January 2, 2020

RE: Lot 2 Block 5, S.A.D. 227 Unser Cliffs Subdivision 6520 Onyx Ct. NW Grading and Drainage Plan

Engineers Stamp Date 12-30-19 (E10D072)

QUALITY BUILDERS - MARTINEZ - LOT 2 GRADING & DRAINAGE PLAN

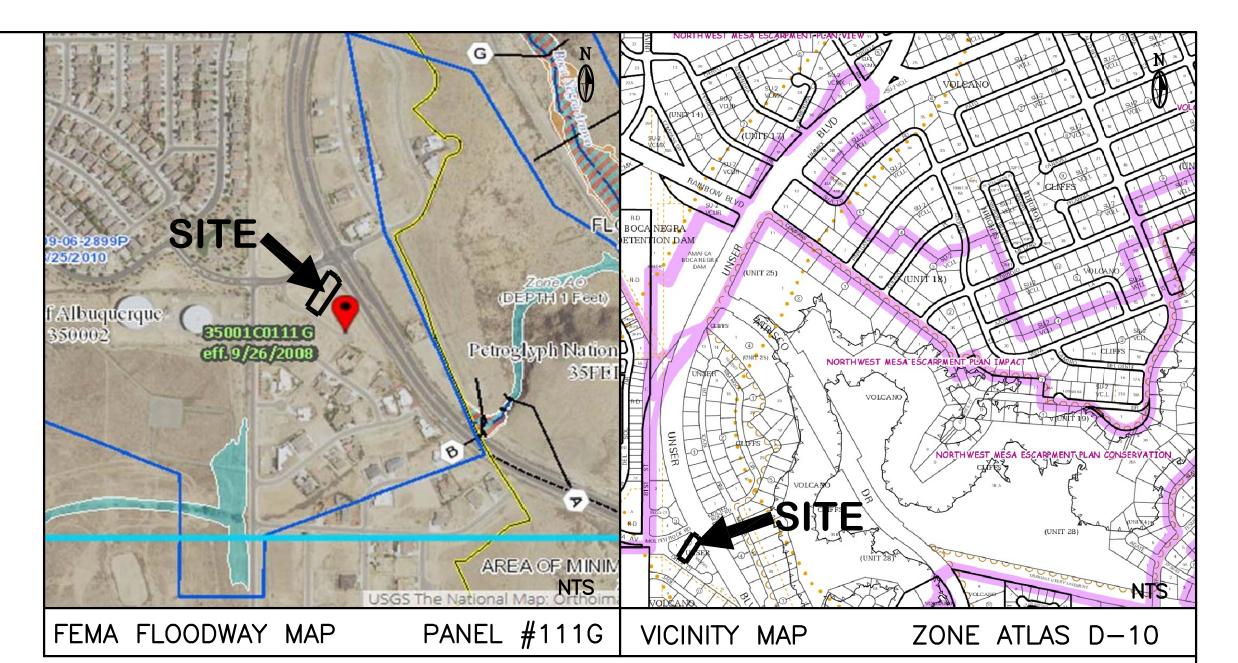
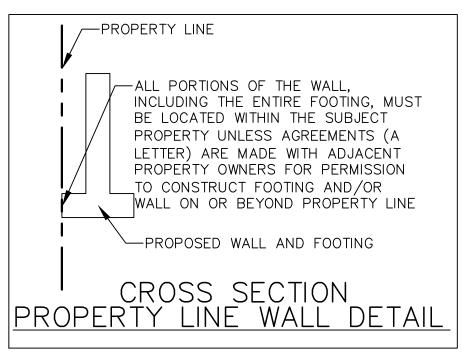
Based upon the information provided in your submittal received 12/30/19, this plan is approved for Grading Permit.

Prior to Building permit approval a Pad Certification will be required, provided by the Engineer or a registered Land Surveyor.

Reiterate to the Owner/Contractor that a separate permit for a garden/retaining wall must be obtained, with the approved G&D plan dated 12/30/19. Also, let the owner/contractor not to use dirt as a ramp to climb the curbing. Only crusher fines or lumber may be used for this process

Prior to Certificate of Occupancy release, Engineer Certification per the DPM checklist of this plan will be required.
